<b>Hillrom™</b> Hillrom Luleå Nedre Vägen 100, 975 92 Luleå, Sweden	<b>Field Safety Notice</b>	 <b>FA-2021-11-004-LUL-002</b>
---	----------------------------	--

**FSCA-identifier: FA-2021-11-004-LUL-002**

**Commercial name of the affected product,**  
Traverse Rail Carrier and Traverse Rail Carrier E-System, wide

**Type of action: Field Safety Notice**

Figure 1

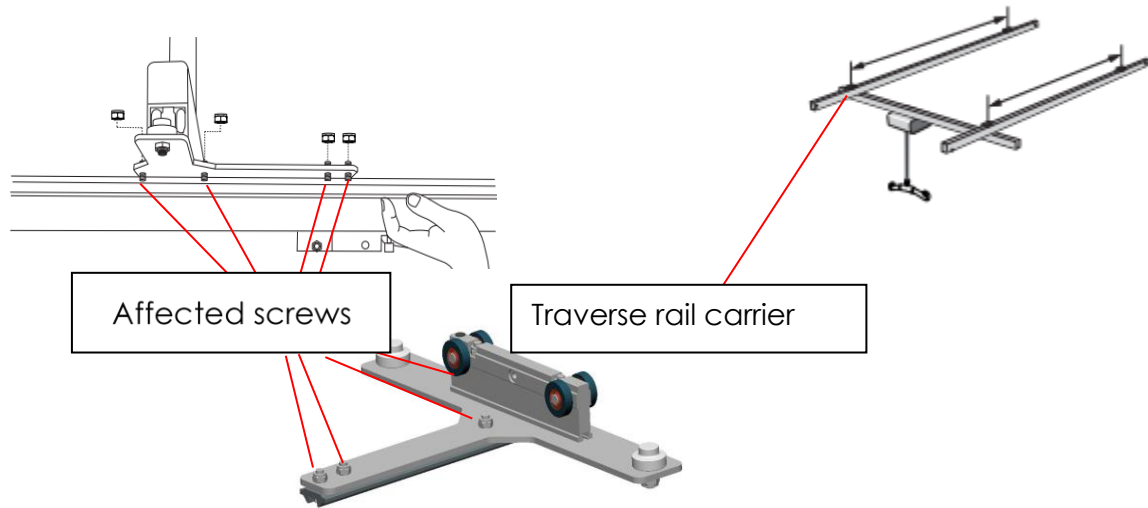
A traverse system consists of two primary rails with a secondary rail in-between. See figure 1 below.
